HIGHWAY WORK PROPOSAL

| <u>COUNTY</u> | <u>STATE PROJECT</u> | <u>FEDERAL</u> | <u>PROJECT DESCRIPTION</u> | <u>HIGHWAY</u> |
|---------------|----------------------|----------------|------------------------------------|----------------|
| St Croix | 7620-00-70 | N/A | Elmwood - Sth 64; Sth 29 To Ush 12 | STH 128 |

Addendum No. 01
ID 7620-00-70
Revised Sheet 80
January 30, 2023

Addendum No. 03
 IF 7620-00-70
 Revised Sheet 50
 February 9, 2023

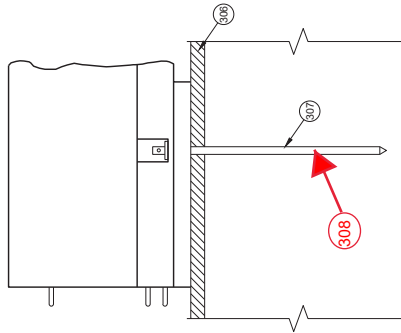
| Revised Plan Sheets | |
|---------------------|--|
| 80 | Added notes to the SDD |
